Item Name: Crosstube Turning Detail

Description: Crosstube Assembly (205/212/412 High Fwd)

DRAWING NO. D212-664-141	TITLE XTUBE ASSY (205/212/412 HI FWD)	REV. D	DART AEROSPACE LTD ENGINEERING ORDER	D.E.O. NO. D212-664-141-D-1	SHEET NO. SHEET 1 OF 2	SCALE NTS
DRAWN	CHECKED	MFG. APPR.	APPROVED	DE APPR.		
DATE 11.04.07	DATE 11.04.11	DATE 11.04.12	DATE 11/04/12	DATE 11.04.12

DRAWING NO. D212-664-141	TITLE CROSSTUBE ASS'Y (205 HI FWD)	REV. D	DART AEROSPACE LTD ENGINEERING ORDER	D.E.O. NO. D212-664-141-D-2	SHEET NO. SHEET 1 OF 1	SCALE NTS
DRAWN <i>IP</i>	CHECKED <i>A>S</i>	MFG. APPR. <i>AB</i>	APPROVED <i>MD</i>	DE APPR. <i>AB</i>		
DATE 11.07.15	DATE 11.07.20	DATE 11.07.21	DATE 11/07/21	DATE 11.07.21	DATE 11.07.21

**D212-664-141/-141B
ASSEMBLY DETAIL**

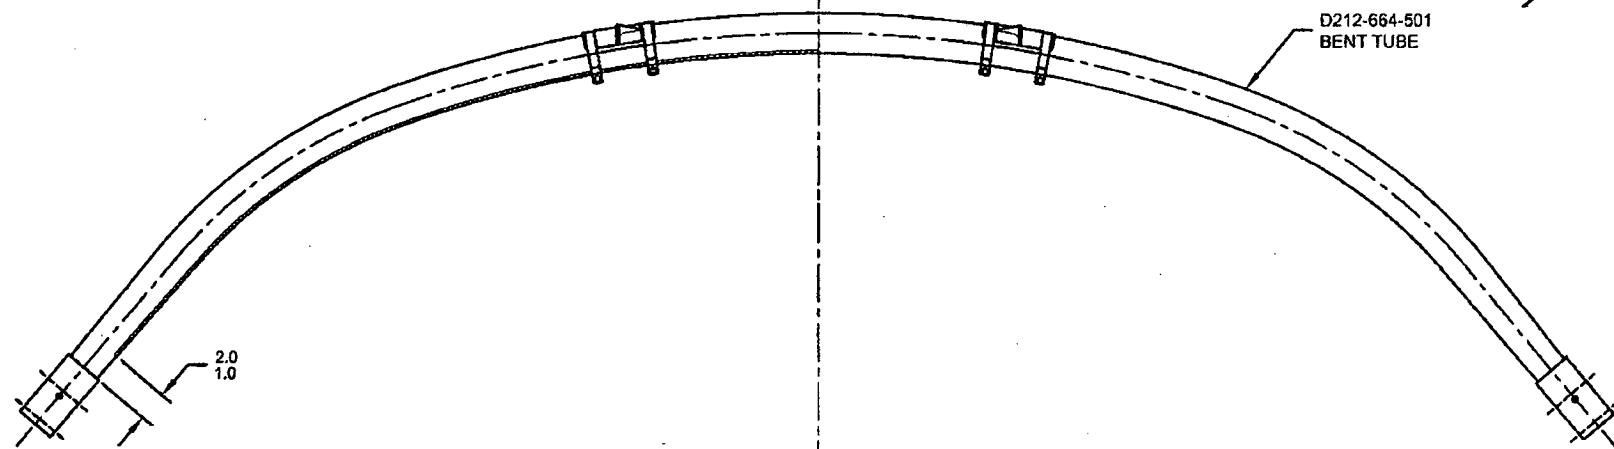
ADD AN INSPECTION WINDOW TO UNDERSIDE OF CROSSTUBE.

MASK AREA PRIOR TO PAINTING,
REMOVE MASKING AFTER PAINT
AND APPLY CLEAR COAT
